LIST OF PROPOSED AMENDMENTS

Attachment 11 – LIST OF PROPOSED AMENDMENTS TO DRAFT LSP

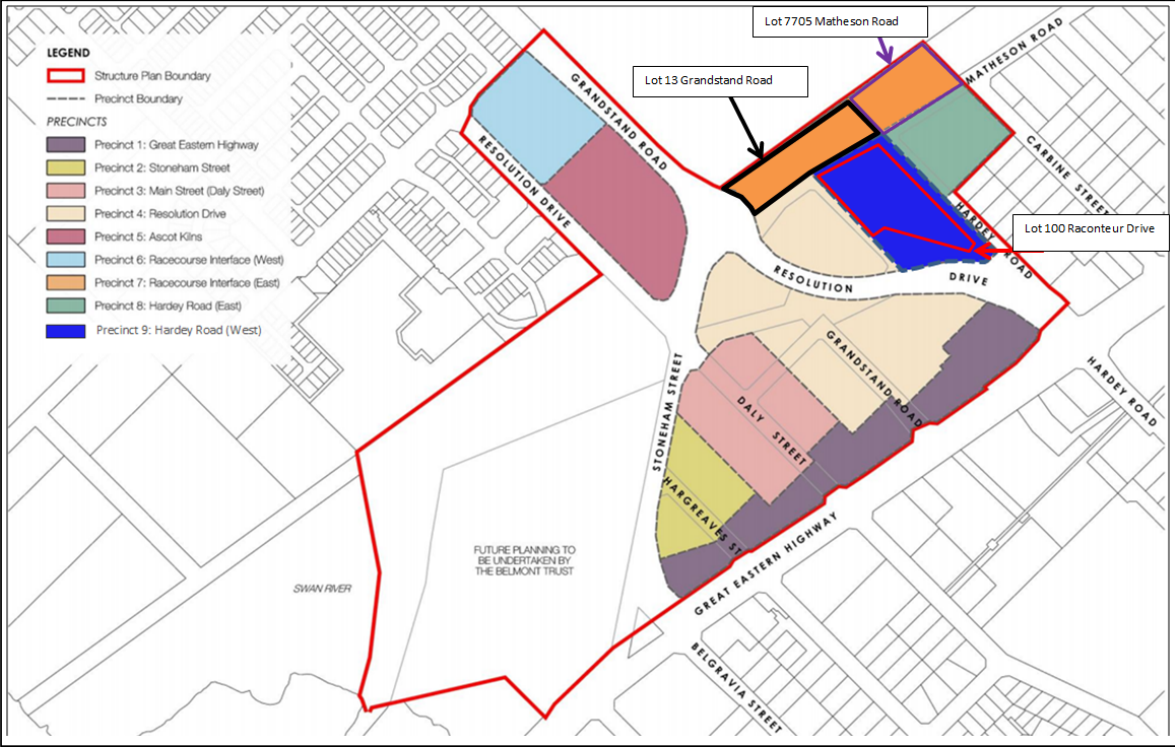
No.	Section of draft Local Structure Plan/Technical Report	Recommended Modification	Reason
		<p>Amend the building heights that apply to Lot 452 Grandstand Road, Ascot as illustrated in the image below.</p> 	<p>appropriate for an R-Coding to be applied to the land.</p> <p>Refer to discussion under the heading Residential Density & Built Form Control in the Officer Comment section of the report.</p> <p>To be consistent with adjacent development within the Ascot Waters Estate and Council's resolution in relation to building height on the Ascot Kilns Site.</p> <p>Refer to discussion under the heading Residential Density & Built Form Control in the Officer Comment section of the report.</p>
